# Historic Preservation Design Review

# HP-09-23, 434 W. Hampton St. (City)

**Request:** Design Review for a fence at a residence.

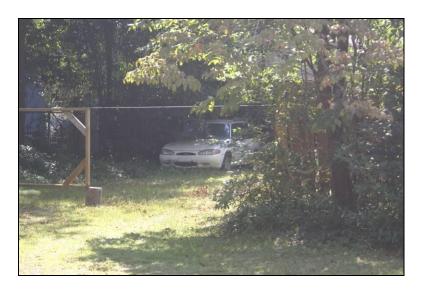
The applicant is requesting Historic Preservation Design Review approval for a 6 ft. high 'dog-eared' wooden board fence that has been erected at 434 W. Hampton Ave. The fence spans 32 ft. and has been erected in the eastern side yard. It extends from the porch to the property line and is in line with the front plane of the dwelling. The front porch is a wrap-around porch; the location of the fence, as shown below on the right, abuts the porch in an awkward location.

Because the fence is constructed of wooden planks and is parallel with the front plane of the residence's primary façade, it is non-conforming. The fence was erected without permits. As seen at the top of the next page, the fence was constructed sometime between September 2009 and October 2009.

The existing fence does not meet the requirements set forth in the design review guidelines. Therefore, staff recommends one of the following options:

Option 1: Remove the fence. The fence can then be replaced with an approved material subject to HP design guidelines and approval.

Option 2: Relocate the fence to at least fifteen (15) feet from the plane of the residence's primary façade.
